**Re: FedEx Ground Drainage Report and Conceptual Grading Plan and Drainage Plan
Engineer's Stamp Date 7-3-14 (K09D026A)**

**FEDEX GROUND ABQ
ALBUQUERQUE, NEW MEXICO**

**RE: FEDEX GROUND FACILITY
TOWN OF ATRISCO GRANT UNIT 5
DRAINAGE REPORT AND PLANS UPDATE**

ENGINEER'S SEAL	FEDEX GROUND ALBUQUERQUE, NM		DRAWN BY DY
RYLAND R. BOHANNAN P.E. #7866	POST DEVELOPED DRAINAGE BASIN MAP	DATE 7-3-14	2013075-BASINS
	 TERRA WEST LLC 5571 ALBUQUERQUE PLACE NE ALBUQUERQUE, NM 87109 (505) 858-3100 www.tierrowestllc.com	SHEET # C2	JOB # 20113075

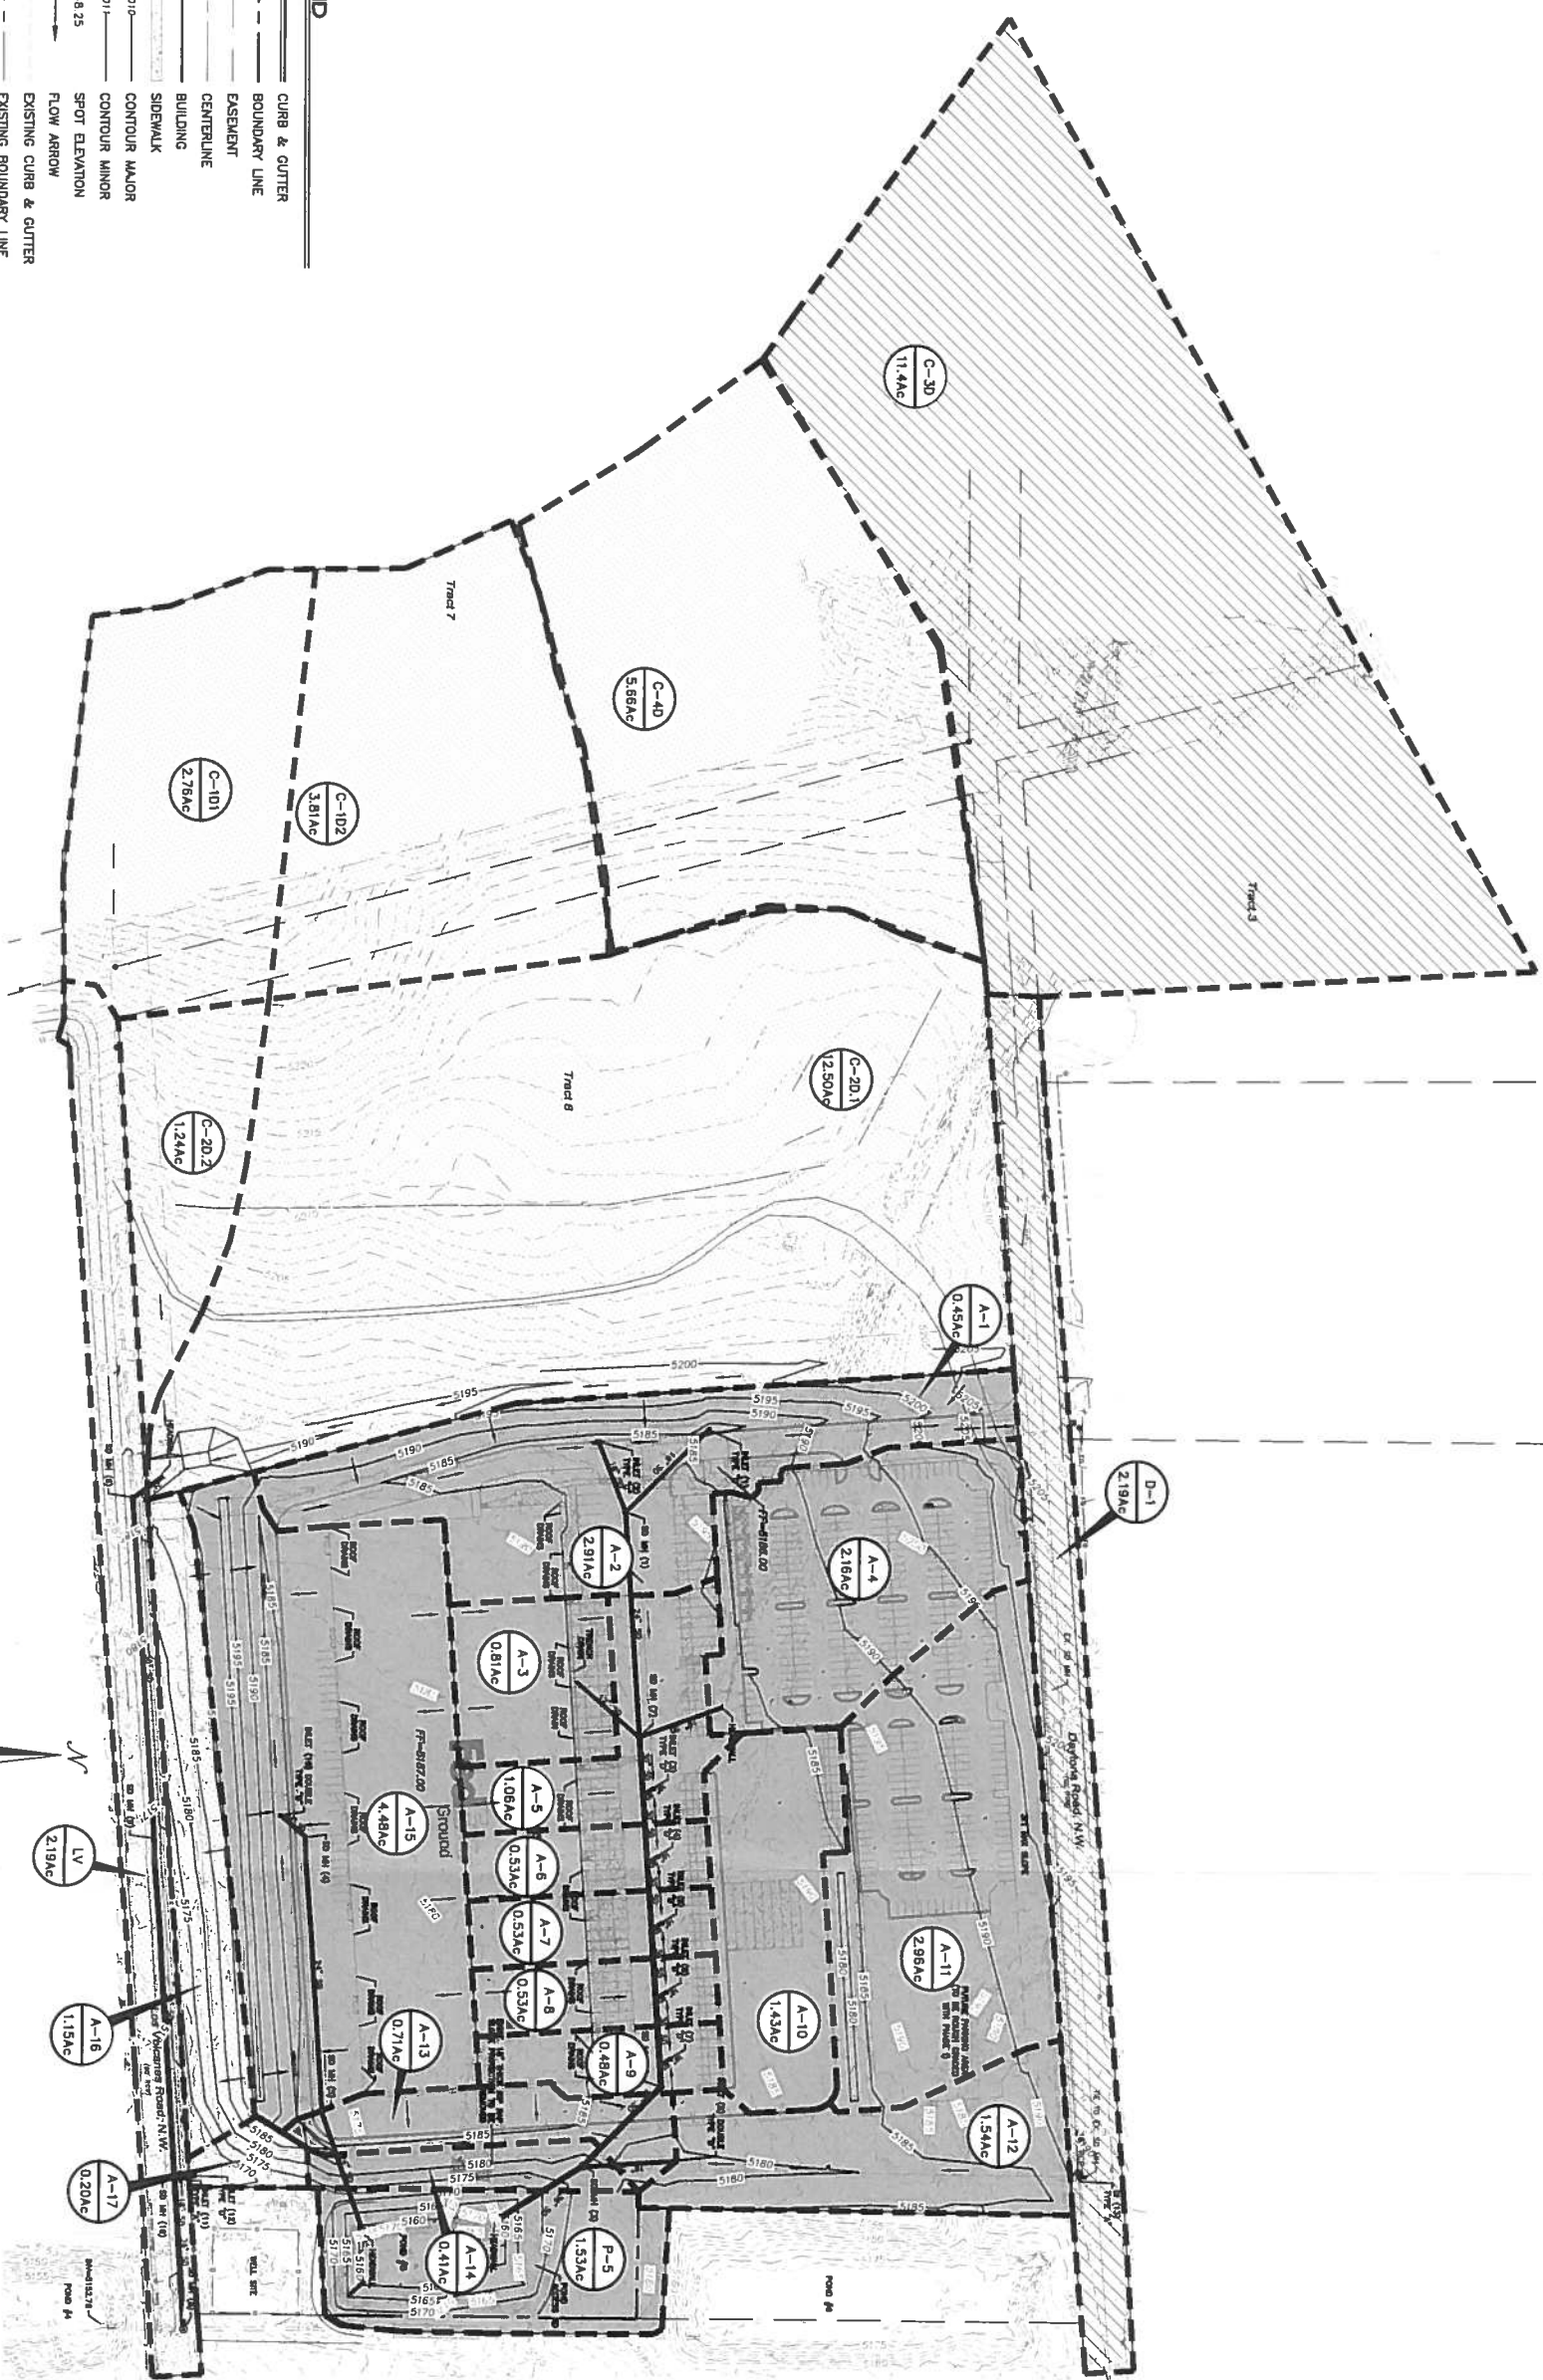
1. The area in the existing conditions that drains to this site appears to be closer to 37 ac, not the 12.5 ac in the report. Show the extents of the offsite basin on a plate.
An Exhibit with the drainage basins under existing conditions was added. Acreages are correctly shown on the exhibit. Drainage from Basin C-3D will be intercepted by the Daytona storm drain that will be extended west into the existing arroyo. A sediment pond will be constructed outside the right of way, upstream of the inlet to the storm drain. Flows from basins C-4D, C-2D.1 and C1D.2 will be intercepted by the proposed swale west of the FedEx property line and conveyed to the Los Volcanos storm drain that will be extended as part of this project. A sediment basin will also be constructed at the inlet to this storm drain. Flows from basins C-1D.1 and C-2D.d will continue to drain to the Los Volcanes right of way as they currently do today.

ISOMETRIC - CONCRETE OUTLET STRUCTURE
100' TO SCALE

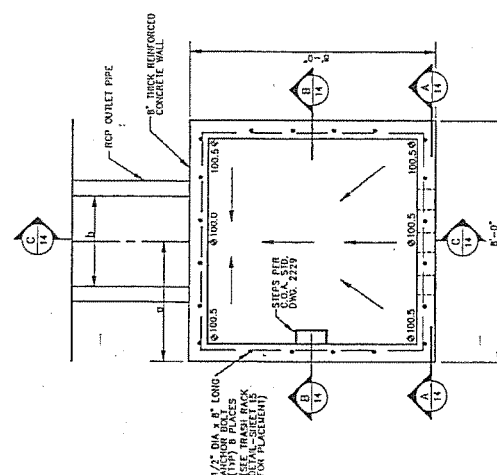
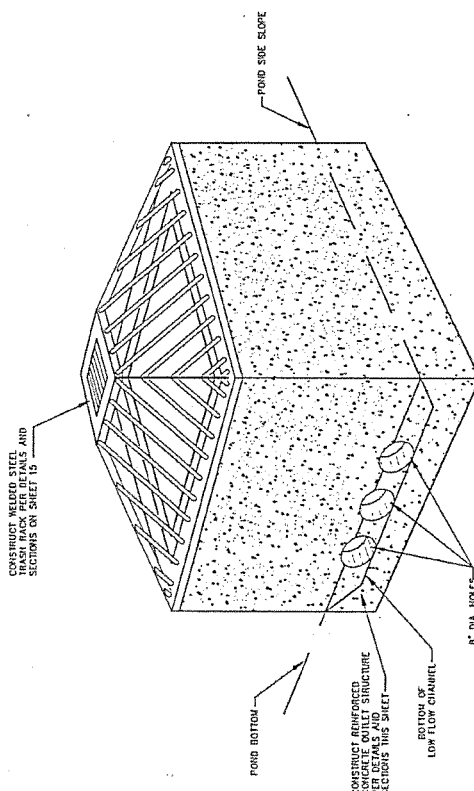
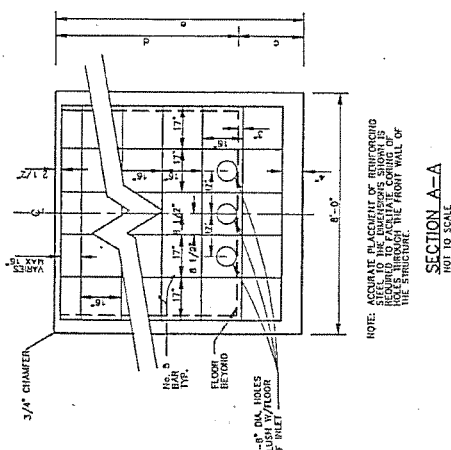
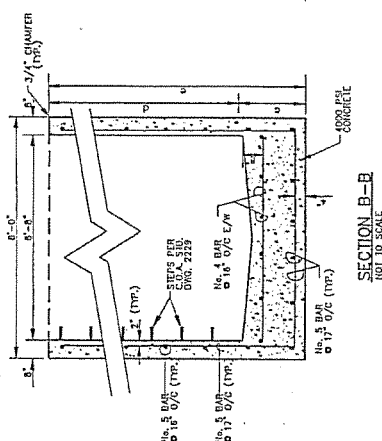
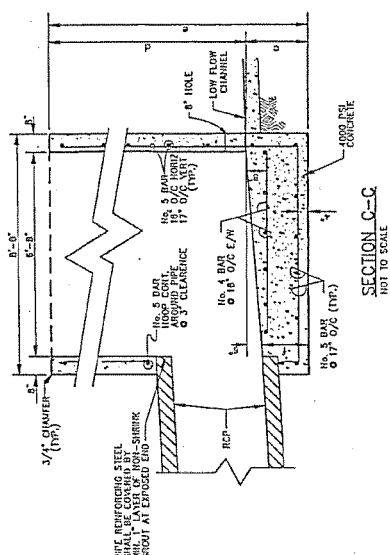
- The plan was not reviewed at the building Permit level; however, when submitting for Building Permit the following items should be addressed:
11. The outlet structure for Pond 5 is to be modified as the existing 8" holes easily plug. Hydrology would like a ported riser design. In addition, provide the as-builts for the outlet structure.
A detail for the modification of the Pond 5 outlet structure to include a ported riser was added to the plans. The as-builts for the existing outlet structure are attached.
